# STATE INDUSTRIAL DEVELOPMENT AUTHORITY OF UTTARAKHAND

## Approval Letter

**Sub: Approval of the building plan unit situated at Plot no- 9, Sector- 8B, IIE, SIIDCUL, Haridwar.**

**PROJECT:-**  
**EXISTING, PROPOSED & ADDITION**  
**ALTERATION INDUSTRIAL**  
**BUILDING FOR SH. SUNIL KUMAR**  
**PASRICHA, PROPERITER AMPRO**  
**AT PLOT NO.-09, SECTOR -8B,**  
**IIE HARIDWAR. UTTARAKHAND.**

DRG. NO. : **AS/AR/SUB/101**

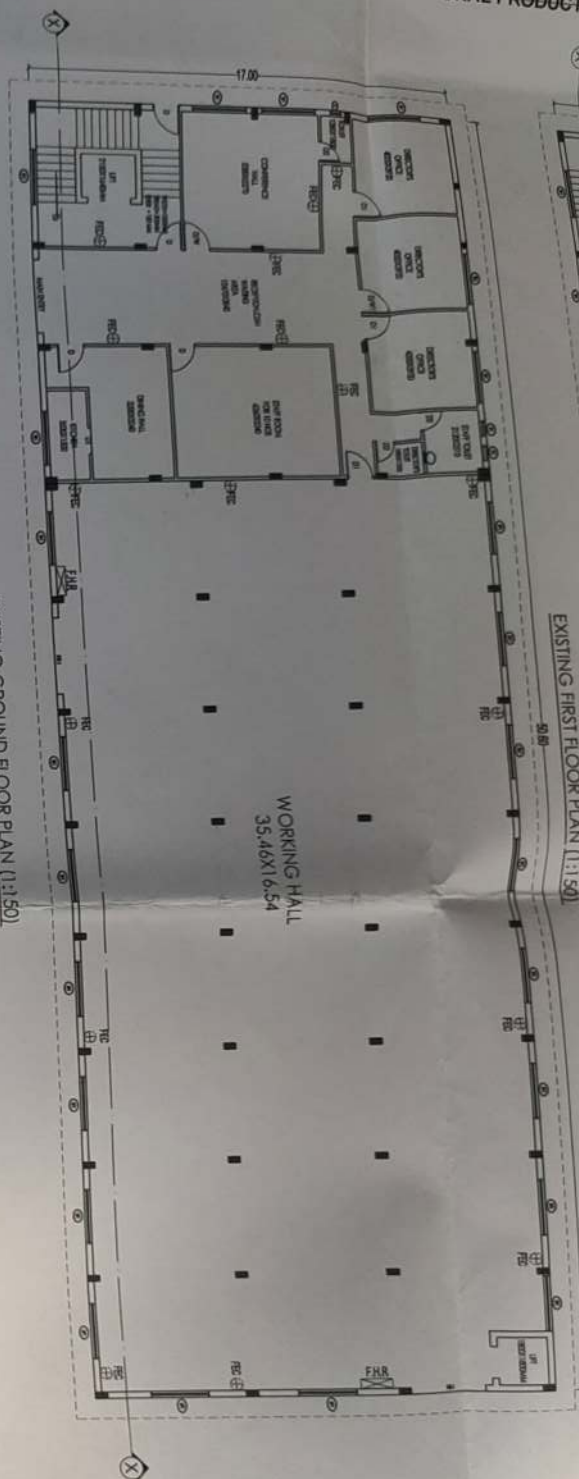
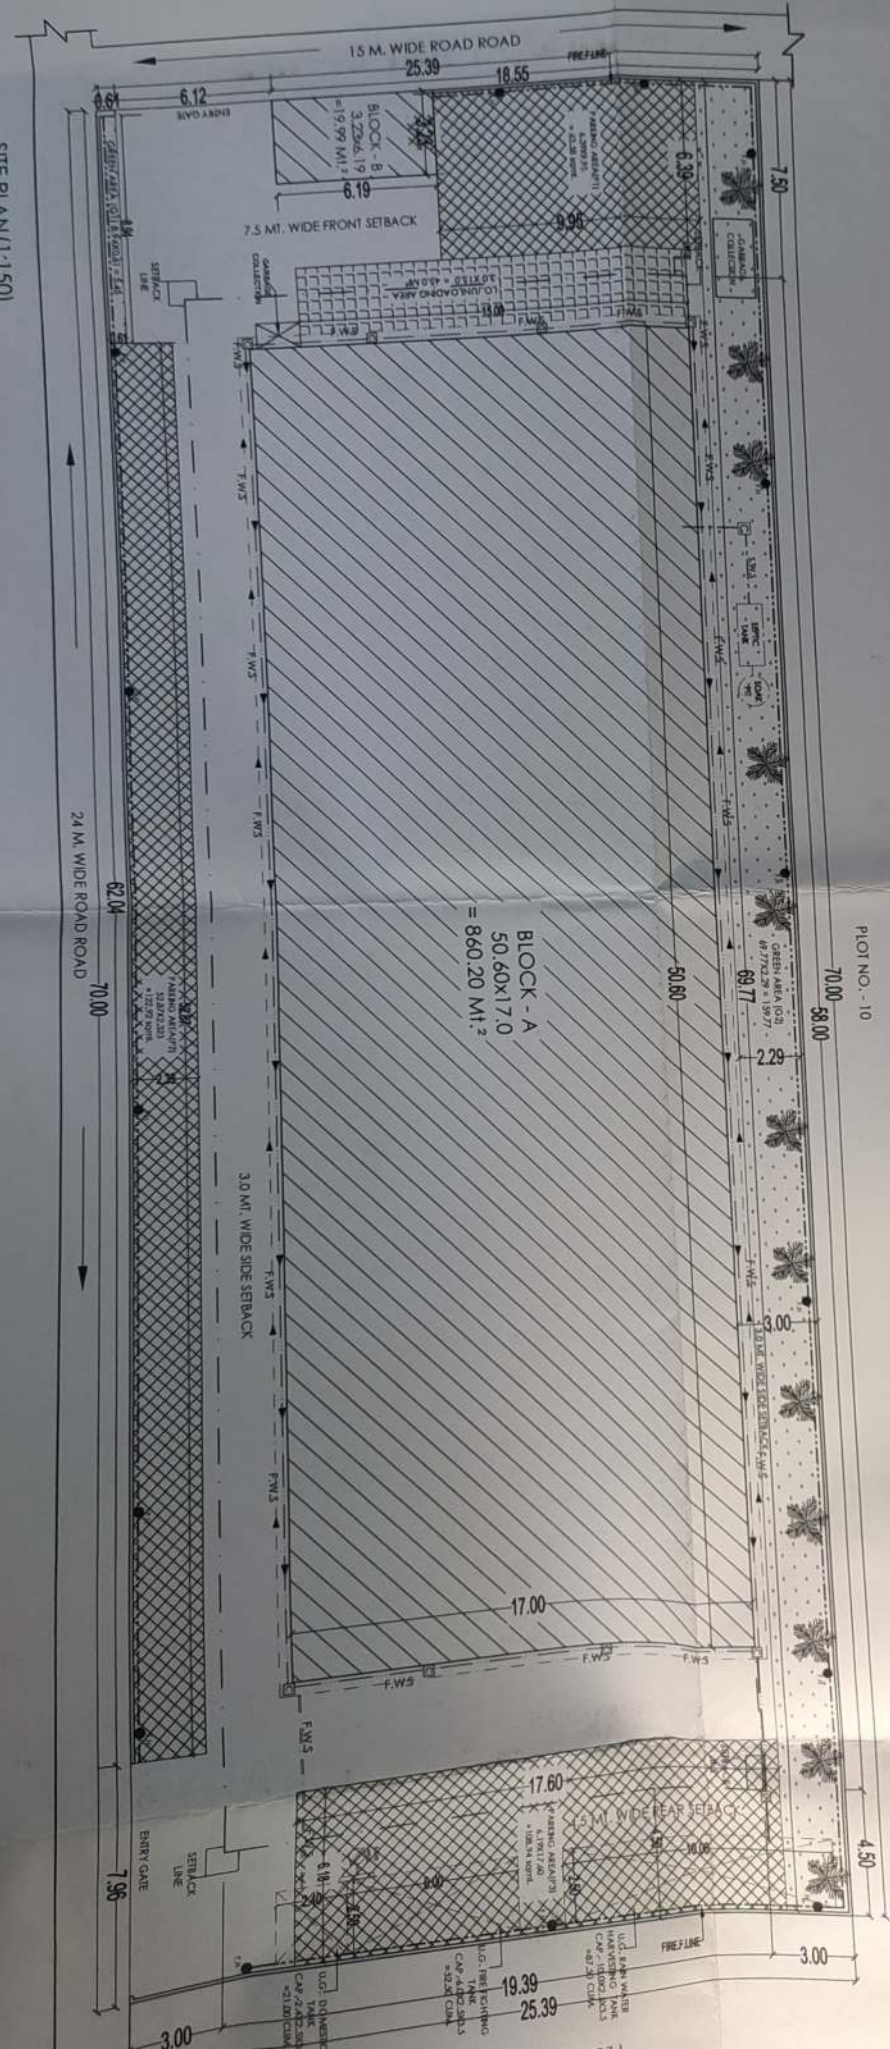
- **Site plan:-**
  1. Rain water harvesting with calculation not shown/ Calculation to be revised.
  2. Vehicular entry/ exit not as per GIDCR-05/12.
  3. Garbage collection space is not shown.

- **Building Plan :-**
  1. Total height of building not marks in the drawings.
